**YARRA CITY COUNCIL**  
**Internal Development Approvals Committee**  
**Agenda**

Item		Page	Rec. Page
1.1	PLN19/0364 - 142 - 144 Coppin Street Richmond - Construction of a four-storey building and reduction in the car parking requirements associated with the use of the land for dwellings and offices (no permit required for office use).	5	44

1. This report provides Council with an assessment of planning permit application PLN19/0364 submitted for 142 – 144 Coppin Street Richmond. The application seeks approval for the construction of a four-storey building and reduction in the car parking requirements associated with the use of the land for dwellings and offices (no permit required for office use). The report recommends approval of the application, subject to conditions.

Eastern façade of proposed development

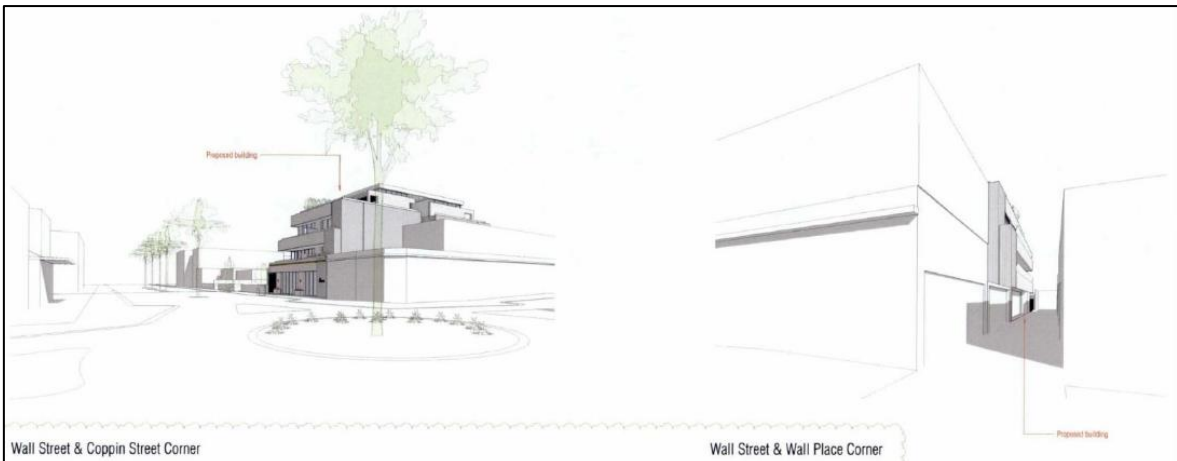
89. Whilst Council's Urban Design Unit has recommended *to rationalise setbacks and balconies along this interface to simplify the overly stepped and bulky form*, these setbacks are required in order to limit off-site amenity impacts to No. 146 Coppin Street. Nonetheless, the applicant submitted S57A plans, reducing the bulk of the southern perimeter of Apartment 3.01's balcony at Level 3 by changing the material from brick to a mixture of powder-coated and perforated metal finish.

90. Council's Urban Design Unit also recommended that in order to ensure the upper forms are recessive at Level 3, *the brick wing walls be removed and a light weight structural form be pursued*. Planning Officers agree with this recommendation and in order to provide emphasis on the two-storey built form found along Coppin Street, Wall Street and Wall Place, a condition will require wing walls to pergolas at Level 3 to be deleted.

- (g) Deletion of wing walls to pergolas at Level 3;
  - (h) Design changes to implement recommendations of the Sustainable Management Plan Condition No. 3 of this permit;

B17 Setback encroachment from No. 146 Coppin Street (CBG Architects & Interior Designers, December 2019)

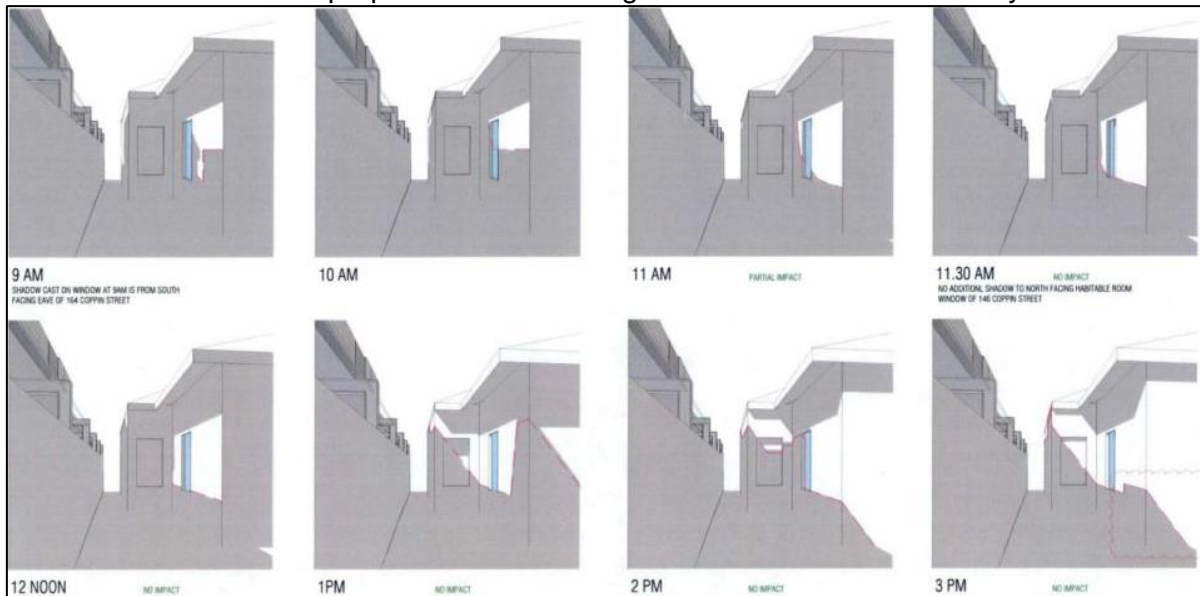
171. The SPOS and one north-facing habitable room window (HRW) associated with the dwelling at No. 146 Coppin Street abuts the subject site to the south. Under this application, a staggered setback design is proposed along this shared boundary; a 1.2m high brick fence, with a 2.2m high timber fence and a 9.5m long x 3.2m high a solid wall. Whilst not strictly applicable, in the absence of policy at *Clause 58, Standard B18 (Walls on boundaries objective)* of *Clause 55.04-2* of the Scheme can be considered to provide some guidance relating to visual bulk. If *Clause 55* of the Scheme applied to this site, then *Standard B18* would allow for a total length 15.25m along this shared boundary at an average wall height of 3.2m above NGL. Given that this proposed wall is limited to a length of 9.5m and a height of 3.2m, the proposed boundary wall is acceptable and will not be visually intrusive when viewed from the SPOS and HRW of No. 146 Coppin Street.

172. With the exception of the lift overrun associated with Apartment 3.01, the remainder of the development meets the setback requirements of *Standard B17 (Side an rear setbacks objective)* of *Clause 55.04-1* of the Scheme. However, as highlighted on below, the encroachment of this lift overrun into the B17 setback line is limited. This element coupled with the use of a mix of materials on the southern façade will assist in reducing the perception of any visual bulk impacts when viewed from the SPOS of No. 146 Coppin Street.
